FORM APPROVED  
OMB NO. 1004-0135  
Expires: July 31, 2010**SUNDRY NOTICES AND REPORTS ON WELLS**  
*Do not use this form for proposals to drill or to re-enter an abandoned well. Use form 3160-3 (APD) for such proposals.*5. Lease Serial No.  
NMLC032592A

☒ Oil Well ☐ Gas Well ☐ Other8. Well Name and No.  
HUMPHREY QUEEN 18

LINN RESPECTFULLY REQUESTS TO PA THIS WELL. PLEASE SEE ATTACHED PROPOSED PA PROCEDURE AND WELL BORE DIAGRAMS.

PROPOSED PA PROCEDURE

# NM P&A Schematic

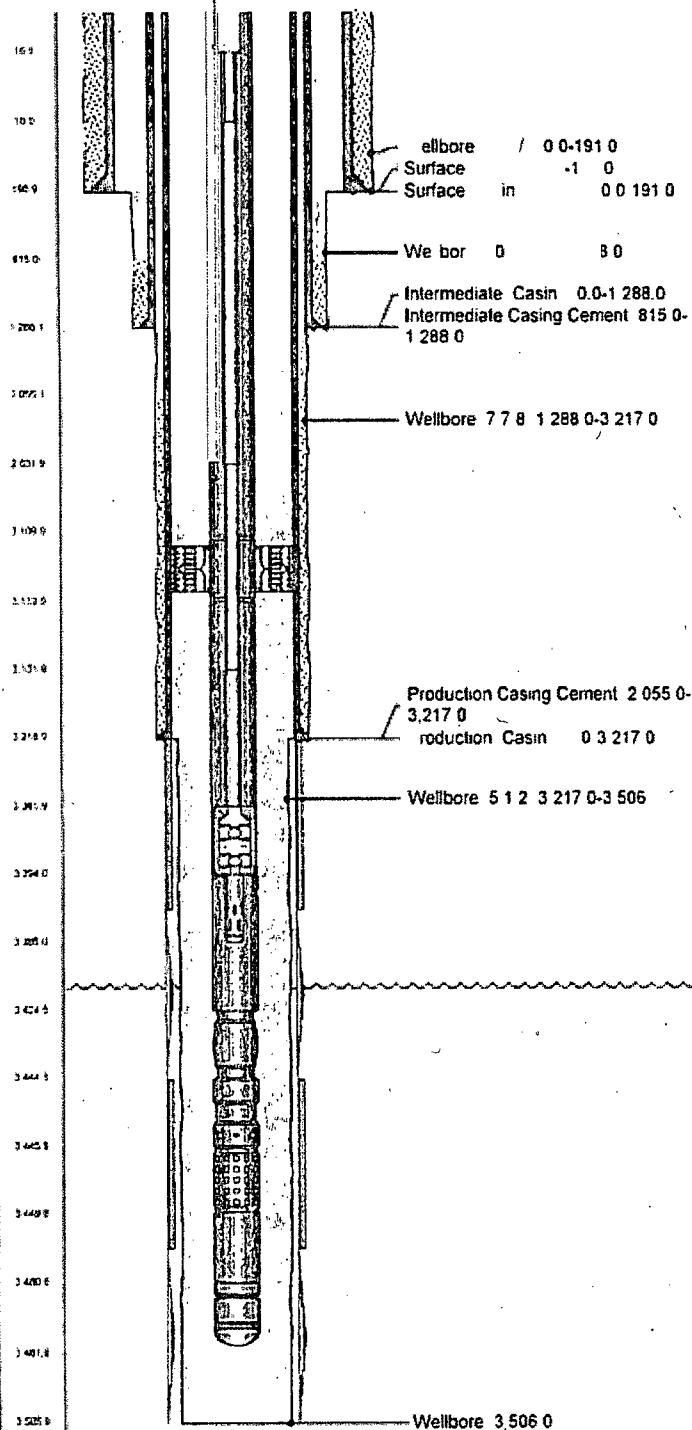
1. Set 7" CIBP @ 3160' circulate hole w/mud laden fluid. Pressure test casing.
2. Spot 25 sx cement @ 3160-~~8000'~~ *3030'*
3. Perf @ 2385' & Sqz 25 sx to ~~2285'~~ *2265'* WOC & Tag
4. Perf @ ~~1340'~~ & Sqz 35 sx to ~~1240'~~ *1345' - 1245'* WOC & Tag
5. Perf @ 245 & Sqz 75 sx to surface - *Deep Penetrating Shots.*
6. Cut off wellhead and weld on Dry Hole Marker

*At cut-off verify cnt to surface all  
annulus.*

P&S cmt 245-Surf. Deep shots

P&S cmt. 1345-1245. woc tag

P&SQZ cmt. 2385-2265. Tag

3160'-3030'  
Set CIBT @ 3160 Cap w 25 sx cmt
